**Flood Control Project Maintenance
Levee Inspections**
LMA District Cover Sheet
Spring 2019 Levee Inspection Results

Levee Inspection Report By Mile - Spring 2019

Waterway	Bank	Unit Miles	Inspection Start/End	Inspector
Unit No. 01 Putah Creek or North Levee	Left	8.79	04/18/2019 04/18/2019	David Julian

Photo 1 of 1 : SP_2019_ST0007_282_29_20190311_00006.jpg

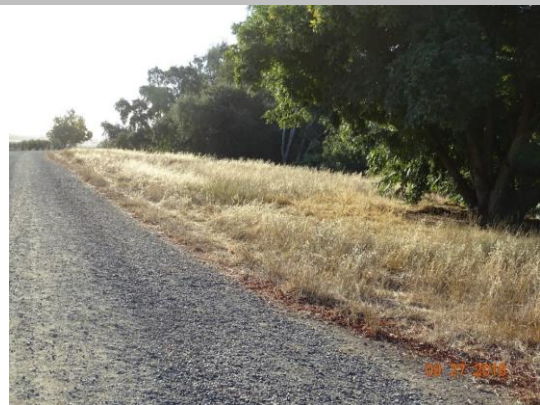
LM Start	8.06	Rating **	M	Issue No.	29
LM End	8.62	Issue Type +	Ma	Location *	WS
Category	Earthen Levee			GPS Latitude/Longitude	
				Start	End
Item	Vegetation			38.519480 °	38.523858 °
				-121.773085 °	-121.781917 °
DWR ID	DWR_ST0007_01_f_2018_29				
Comment Code					
V1 : Control annual grass and weeds on the levee slopes and easements.					
Inspector Comment					
Maintain the vegetation on waterside slope.

View looking downstream at thick vegetation up to the crown (September 2018).
